CONSTRUCTION PHOTOS OF EUT

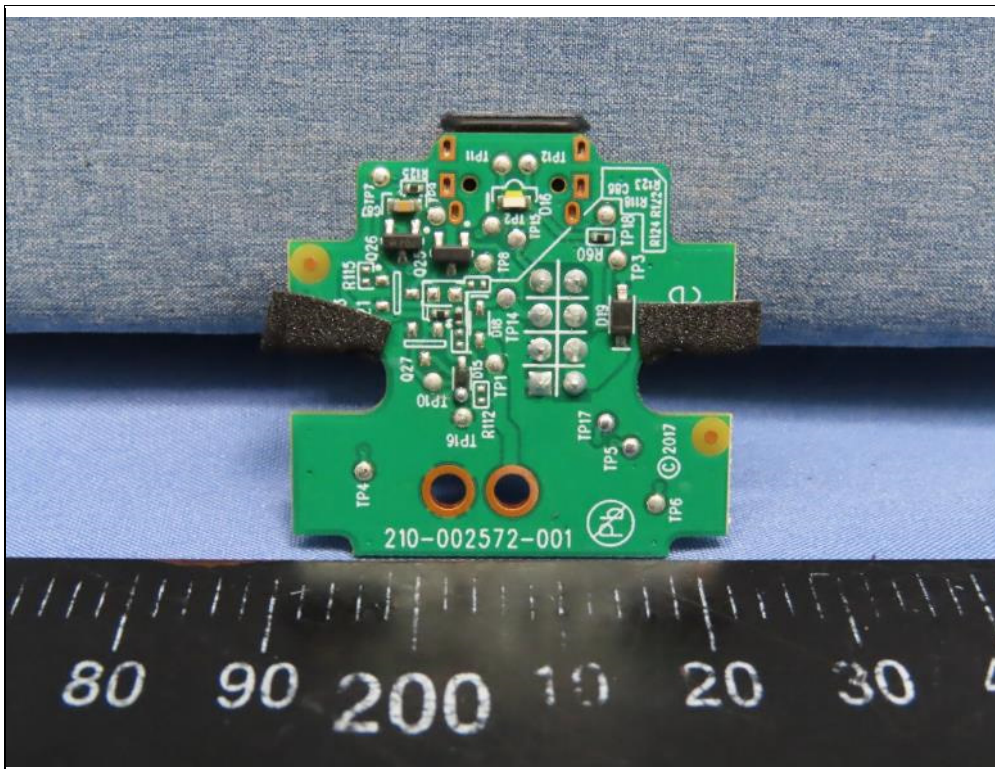
Change Top/Vol board from 2Layers to 1Layer

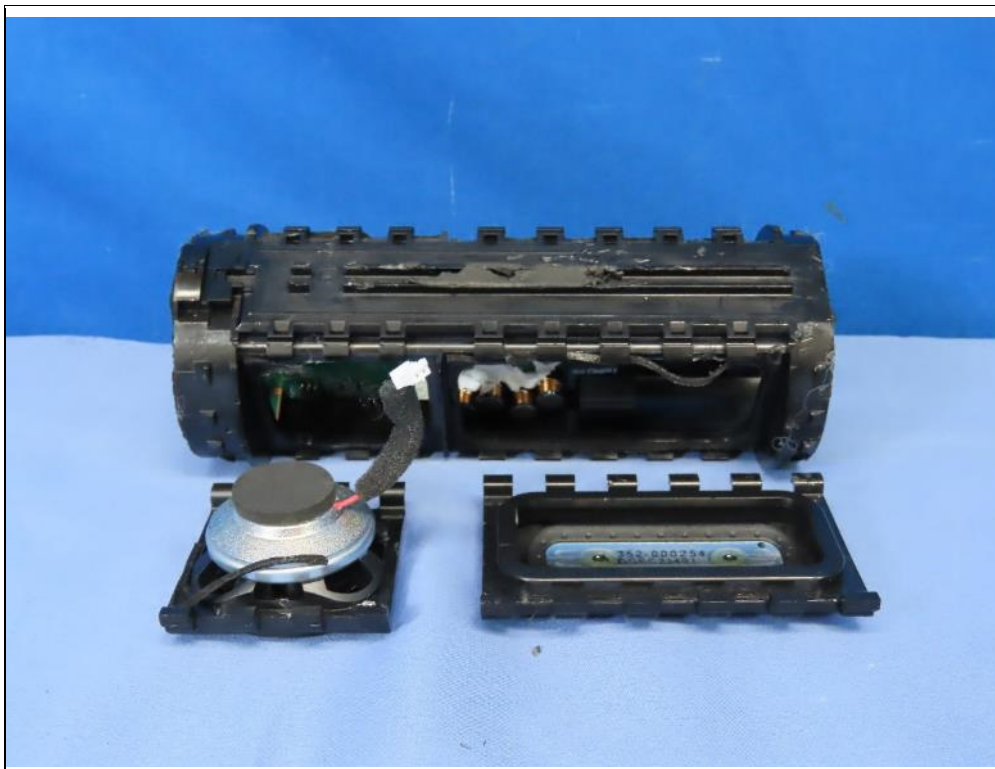
Remove_Charging Dock

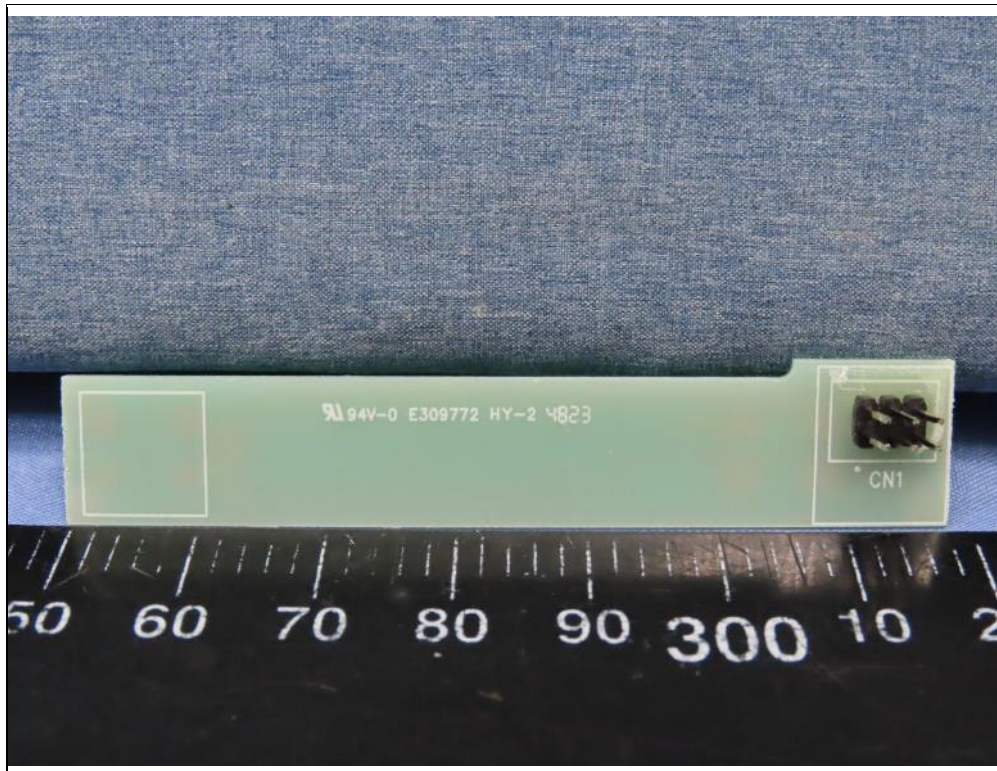
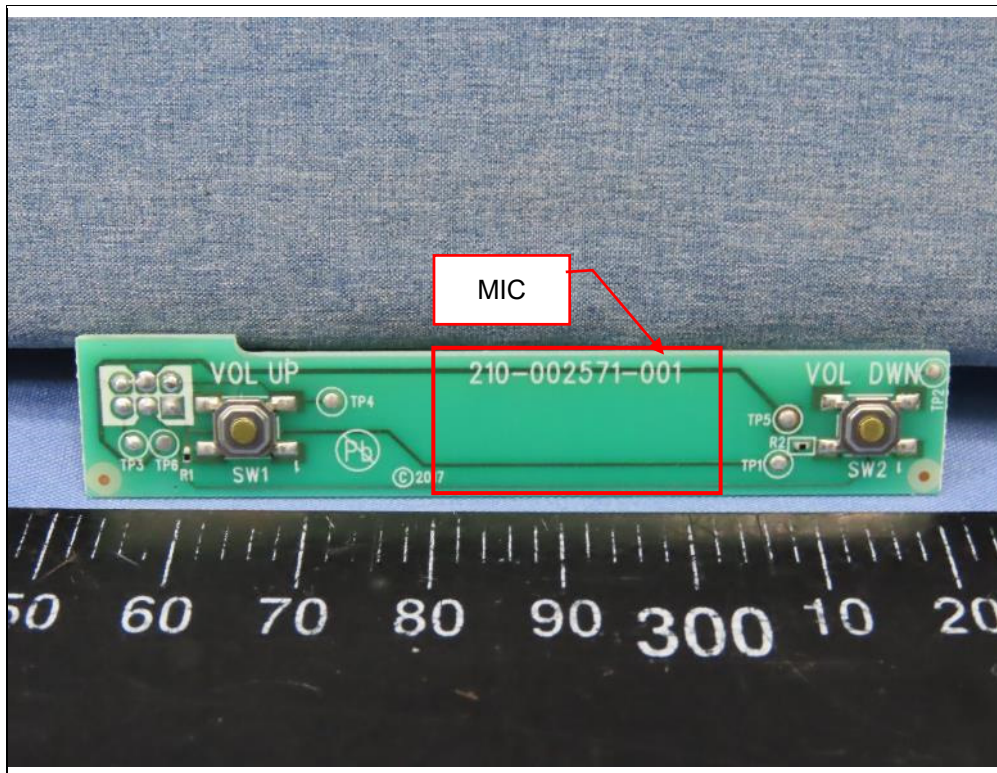
Change Top/Vol board from 2Layers to 1Layer, and remove the layout of MIC from Vol board

Change Inductor of AMP (L5-L8) from 302-000435 to 302-000413 / Remove C127 capacitor
